**RE: SUPPLEMENTAL INFORMATION REQUESTS - ALBERTA SULPHUR
TERMINALS SULPHUR FORMING AND SHIPPING FACILITY**

This letter provides responses to the Supplemental Information Requests (SIR's) included in your letter of January 4th, 2008. For ease of reference, each question is reiterated in italics prior to providing the supplemental information.

Figure 2.4-2: Existing Monitoring Network and Cross Sections

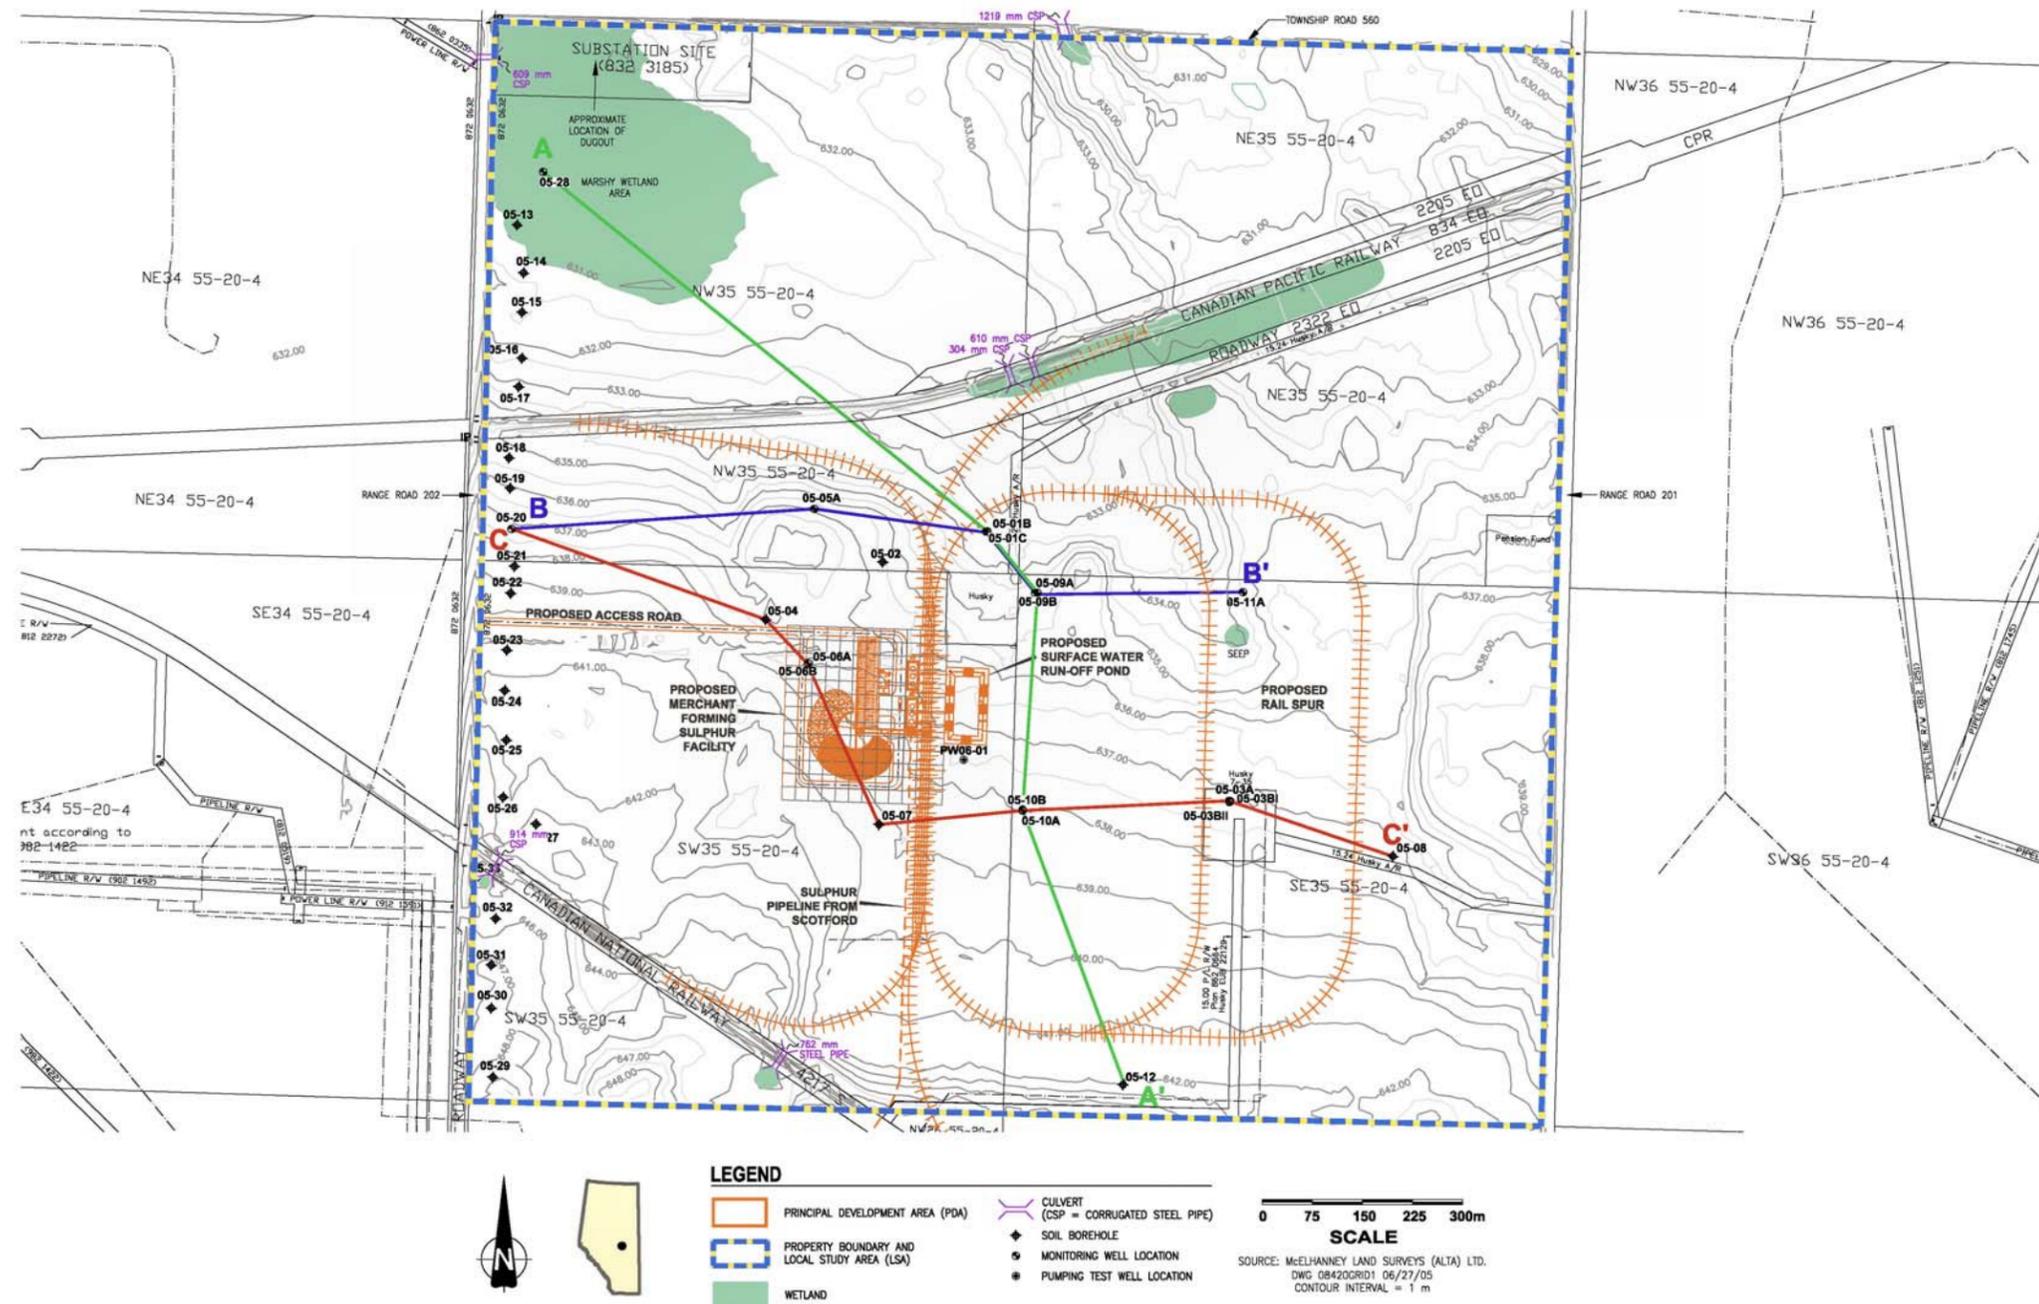
- c) *If drawdown occurred in monitoring well 05-02, explain why this was not used to confirm the aquifer storativity when determining the distance/drawdown relationships given in Figure 2.6-1.*

- A. During the 24 hour pumping test, groundwater levels were recorded at the following monitoring wells: 05-01C, 05-06B, 05-09A, 05-09B and 05-10B. No drawdown was observed in any of these monitoring wells (i.e., groundwater levels at these locations did not vary in response to pumping at well 05-01B).

- B. No drawdown was observed in the 05-09 monitoring wells. Therefore, no conclusion can be drawn regarding the hydraulic connection between the sandstone aquifer and the overlying drift sediments.
- C. No drawdown was observed in the 05-02 monitoring well. Therefore, aquifer storativity cannot be calculated using the data generated at this location.

Figure 23-1: Hydrochemistry in Belly River Formation

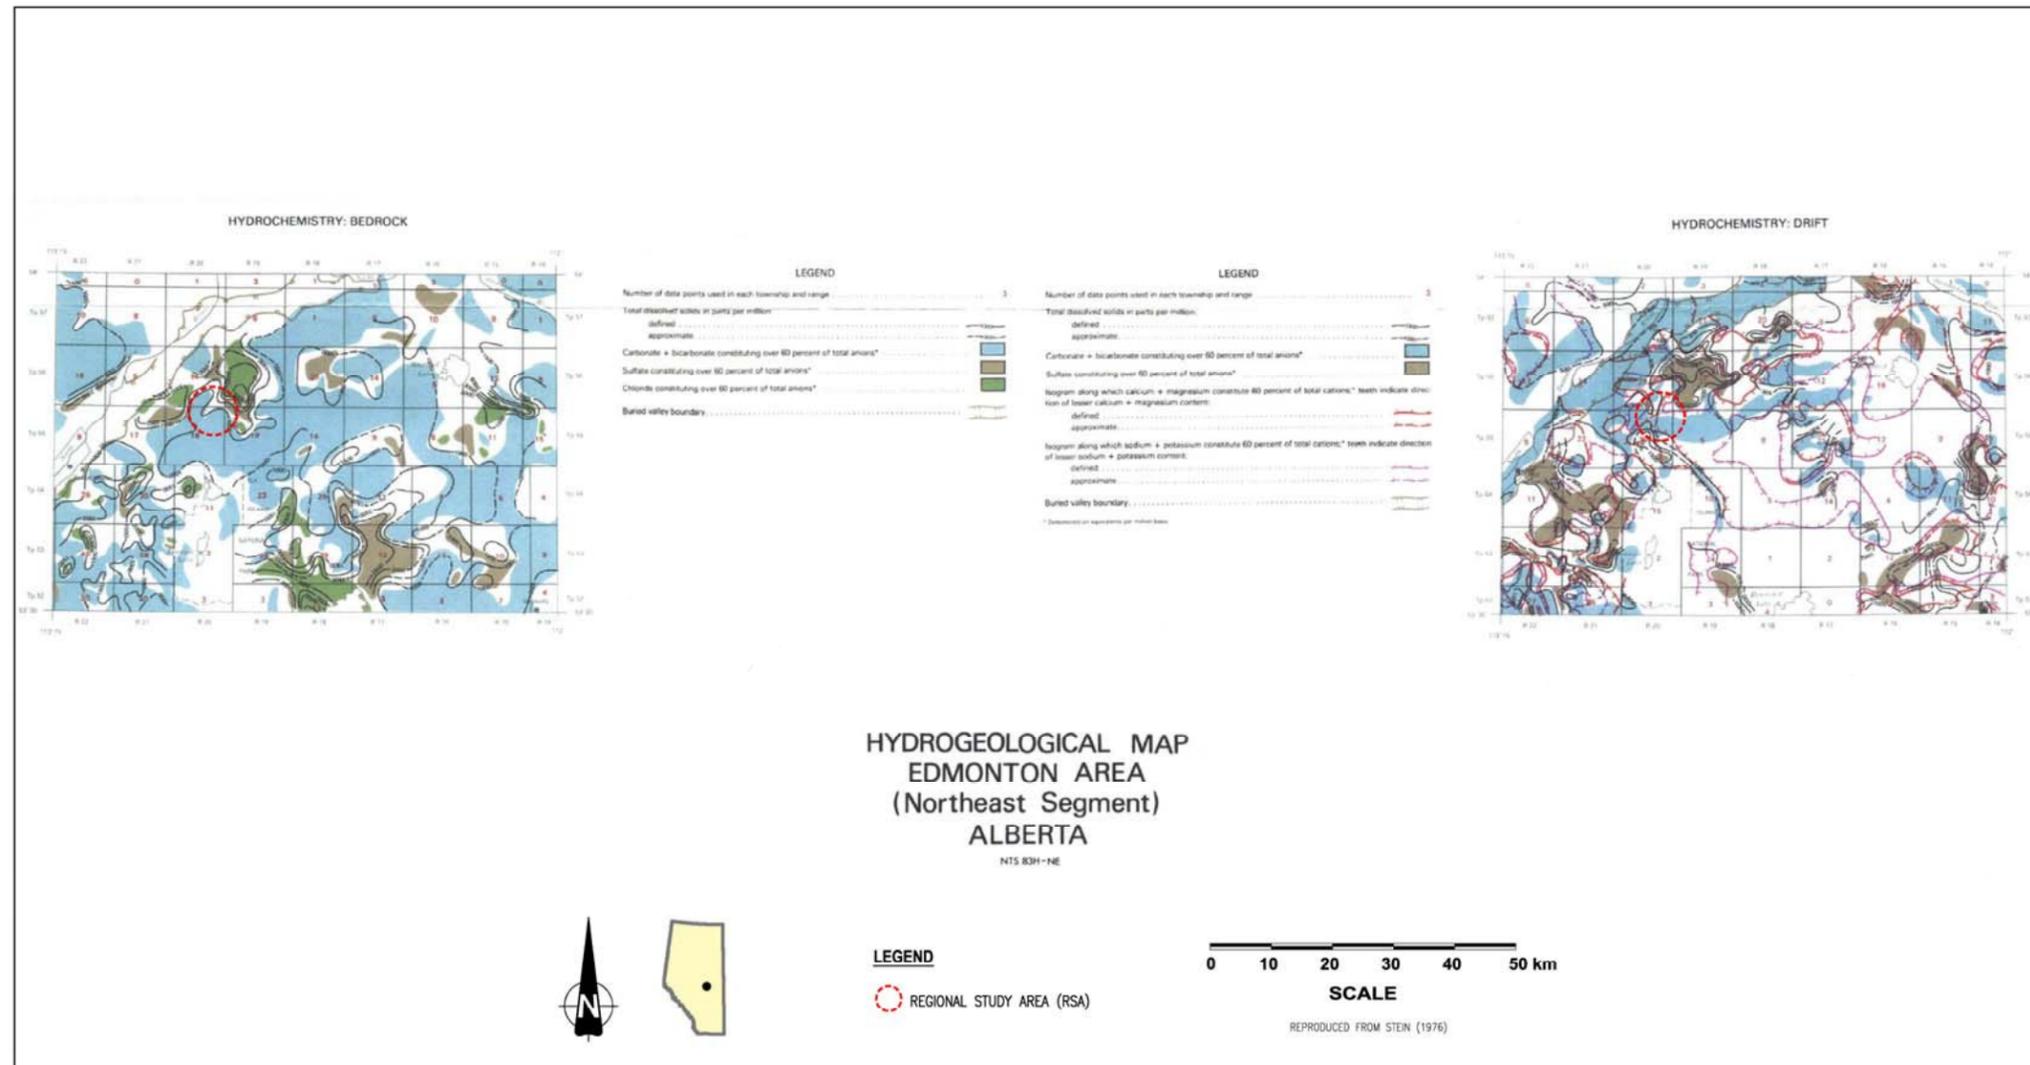
- a) *Provide a map showing the distribution of sulphate in the various sandstone units of the Belly River Formation and the surficial sands in the RSA.*

- b) *Is it possible that elevated sulphate concentration detected in monitoring well 05-20 originates from an off site source? Provide evidence to support your conclusion.*

Elevated dissolved sulphate concentrations were encountered at wells 05–03A, 05–20 and 05–28 (Section 2.5.6.1; Table IV-3). Based on the inferred groundwater flow direction in the surficial deposits (Figure 2.5-7 of the EIA) any off-site source for elevated dissolved sulphate at MW05-20 would have to be located upgradient, to the south-southwest. Two manufacturing plants are located in this general direction:

Inferred groundwater velocities in the surficial deposits are interpreted to be sluggish, ranging from several centimetres to several metres per year with an average of only about 0.2 m/y (Section 2.5.4.2) and a maximum of 4.8 m/y (Question 22). The Canexus facility is located closest to MW05-20, but even then groundwater travel times greater than a hundred years would be predicted. The Triton facility is located ever further upgradient of the Site. It is therefore improbable that the elevated sulphate at MW05-20 is related to either the Canexus facility or the Triton plant. In combination with the evidence regarding regional ambient groundwater quality (Question 23a), AST is confident that the elevated dissolved sulphate is a natural occurrence.

Figure 2.5-3: Cross-section A-A

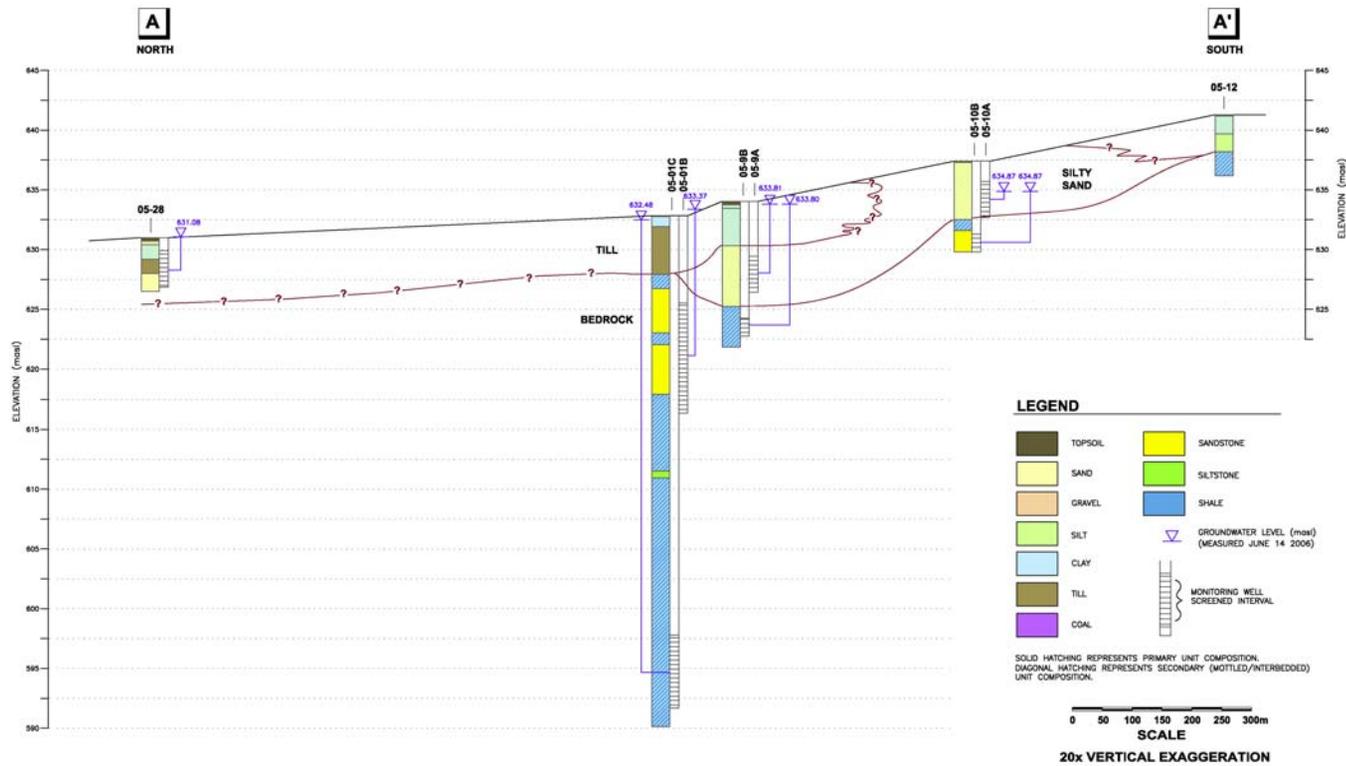
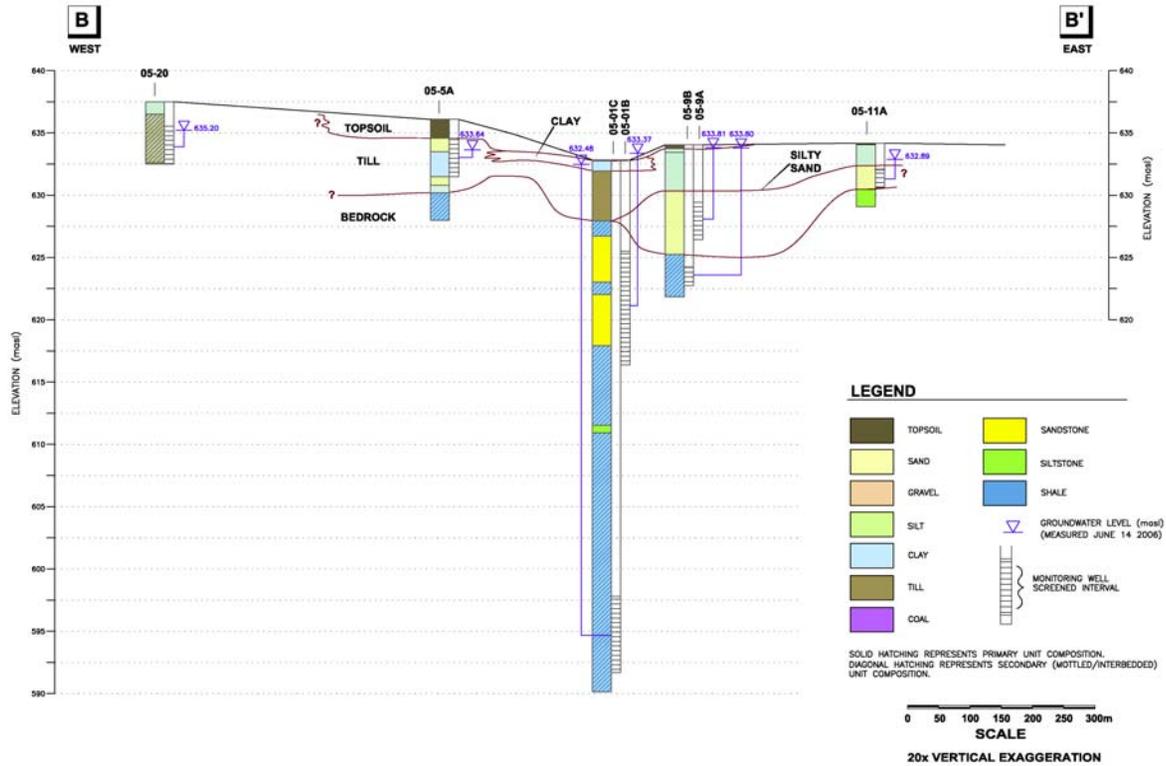
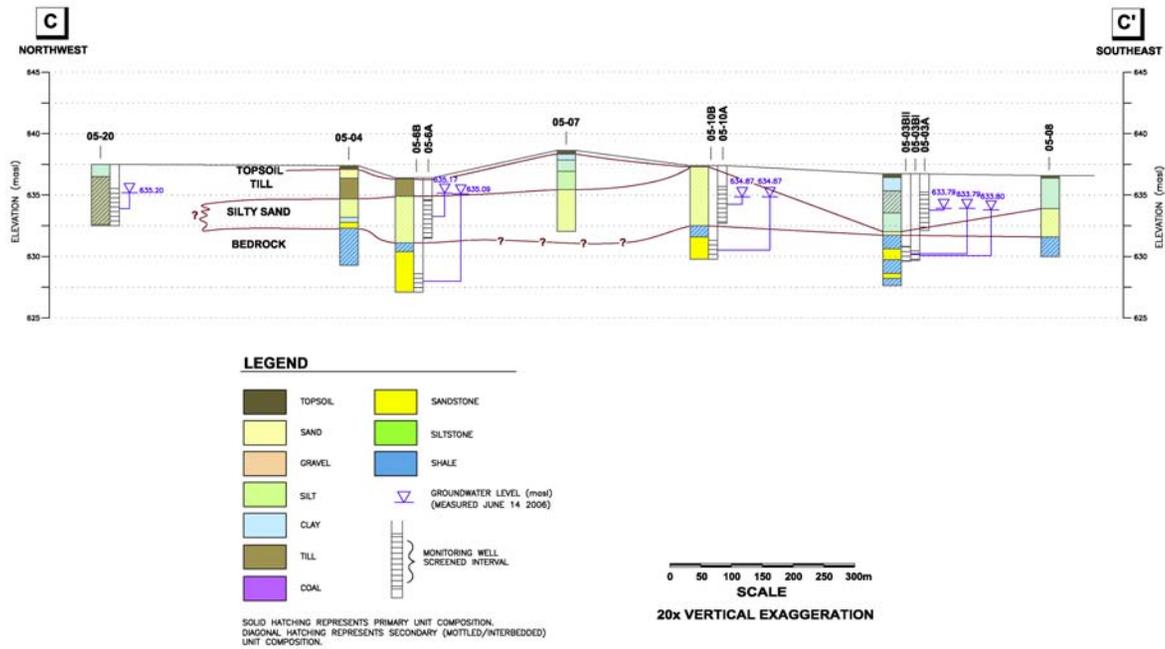
- Provide the rationale for AST's assumption that there is a low permeability material present taking into consideration the lack of available lithologs for this area. How does AST intent to address this data gap?*
- Provide additional information including geological cross-sections of the overlying till that would verify the above assertion.*
- Provide a hydrogeological cross section to demonstrate that the upper bedrock aquifer maintains a confined status across the study area.*

- B. Cross-section A-A' (Volume IIB, Figure 2.5-3 in the EIA) represents a north-south transect across the PDA that includes the wetland area and the above-mentioned well MW05-28. Geologic logs for soil boreholes along the Site west perimeter (Komex, 2006)) also suggest continuity of the (silty) clay and clay till between the wetland and the PDA with a gradual southward increase in total thickness of these low-permeability materials to about 5 m at the PDA (MW05-20). The borehole logs from Komex (2006) are included herein as Attachment 3.

- C. Three hydrogeological cross-sections were provided in the EIA (Volume IIB, Figures 2.5-3 to 2.5-5). These cross-sections provide evidence that the upper bedrock aquifer maintains a confined status across the western and northern portion of the Site. Geologic logs for soil boreholes along the Site west perimeter (Komex, 2006) also suggest continuity of the confining

clay and till between the wetland and the PDA with a gradual southward increase in total thickness of these low-permeability materials.
